HeyPhone External Components Wiring - Issued: 25-May-21

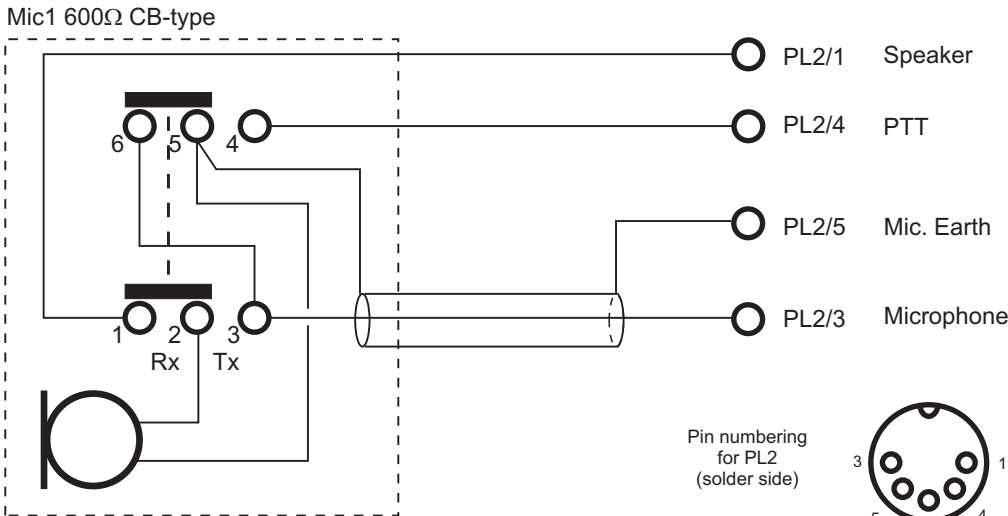
Change from 01-Dec-02 Version: Microphone section redrawn to better illustrate internal wiring arrangement and to remove interconnection shown in microphone wiring between Mic. Earth (PL2/5) and Earth (incorrectly labelled PL2/1).

Modification of Mic1 involves replacing standard plug by PL2, using pin 1 of switch as a binding post for the wires to the microphone insert and the cable screen.
